Flight Procedures Cover Page	Task Action: FLIGHT CHECK	Task Type: IAP	Estimated Chart Date: 03/19/2026	APWS Task ID: 9417368274DD4C1EB22FC1B5473780C5	APWS Project ID: 38C4D3376A724C3987525CC2789303D7
Procedure: RNAV (RNP) Z RWY 35R AMDT 1		Enroute: NO	Specialist: Purnell, Troy		Agreement Number:
Airport ID: KDEN			Airport City: DENVER		State: CO
Facility ID:	Facility Type:	Flight Inspection Remark Type: New FC Slot

Denver, CO
Denver International, KDEN
RNAV (RNP) Z RWY 35R

Subject: APPROVAL: DENVER, CO KDEN RNAV (RNP) Z RWY 35R

RNAV (RNP) Z RWY 35R

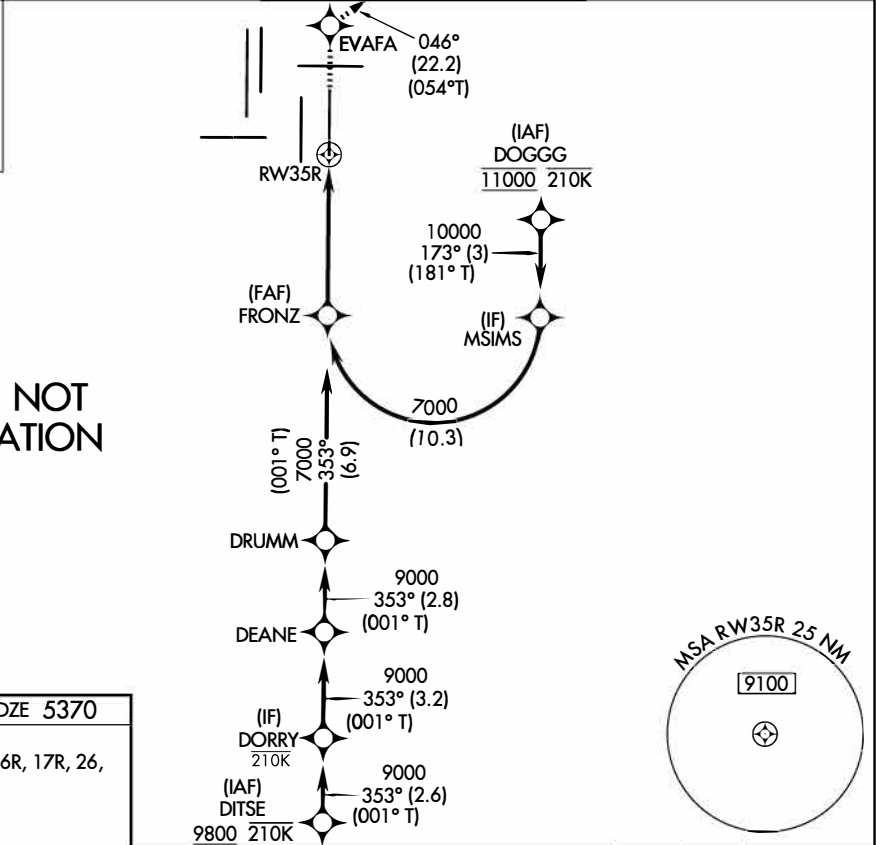
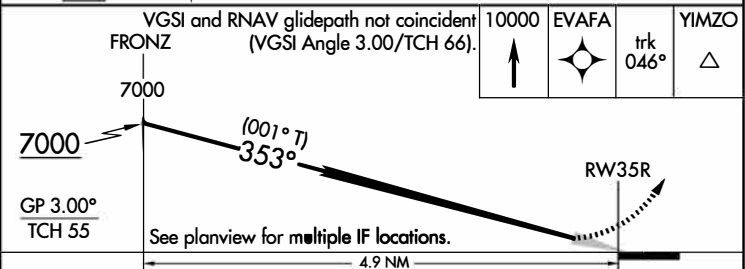
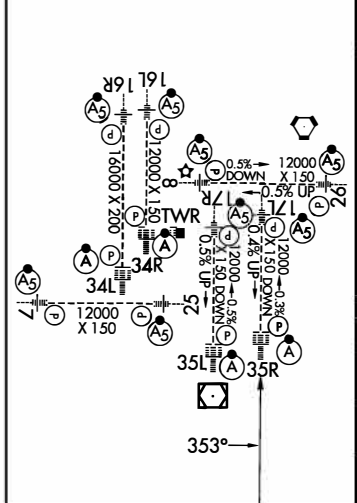
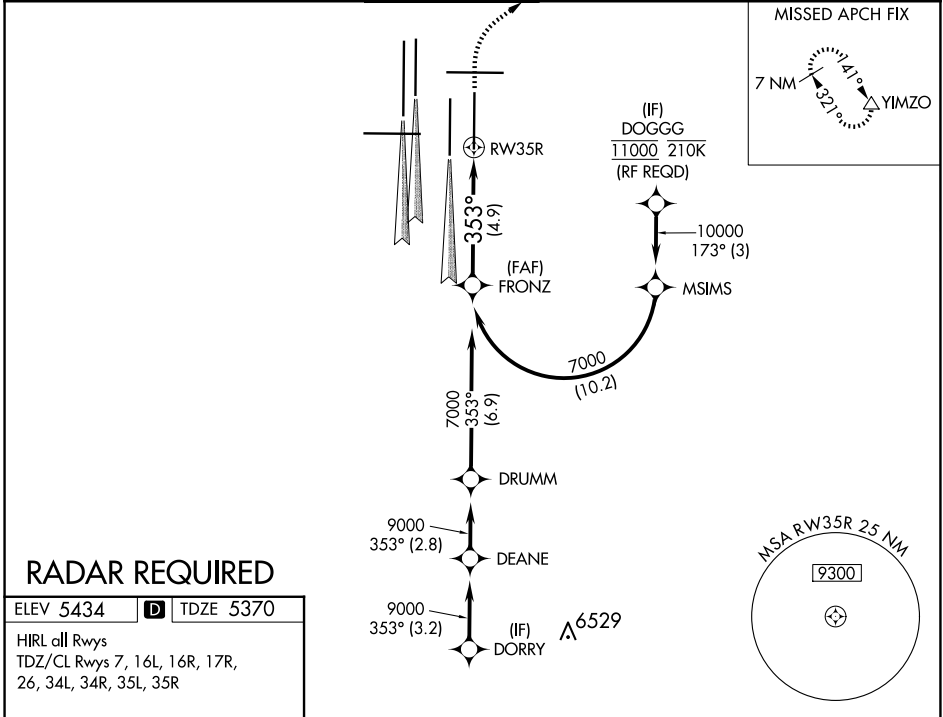
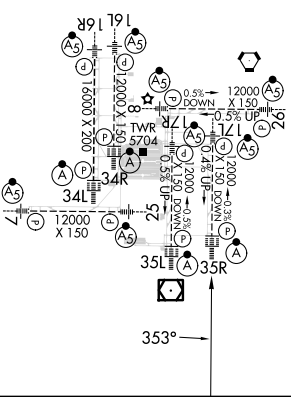
Procedure Comments:
CHANGE MISSED APPROACH. ADD INITIAL APPROACH SEGMENT AT DITSE TO MATCH CURRENT ILS APPROACH. AFS REQUIRED.

1. FIX EVAFA MOVED FROM 395805.20N/1043002.90W TO 395352.34N/1043827.24W.

1. MISSED APPROACH: CHANGED MISSED APPROACH FROM "CLIMB TO 5900 THEN CLIMBING RIGHT TURN TO 10000 DIRECT EVAFA AND ON TRACK 044.37 TO YIMZO AND HOLD" TO "CLIMB TO 10000 DIRECT EVAFA AND ON TRACK 045.88 TO YIMZO AND HOLD"; EVAFA NOW A FO FIX.

2. NOTES: ADDED CHART SPEED ICON IN PLANVIEW AT DORRY: MAX 210 KIAS.

3. NOTES: CHANGED "FOR INOPERATIVE ALSF..." TO "FOR INOPERATIVE ALS..."

1. UPDATED WAIVER FROM "DORRY TO DEAN" TO "DITSE TO DORRY"; VECTOR ANGLE RESTRICTION.

For uncompensated Baro-VNAV systems, procedure NA below -26°C or above 54°C. For inoperative ALS, increase RNP 0.10 all Cats visibility to RVR 4500. Simultaneous approach authorized.

MISSED APPROACH: Climb to 10000 direct EVAFA and on track 046° to YIMZO and hold.
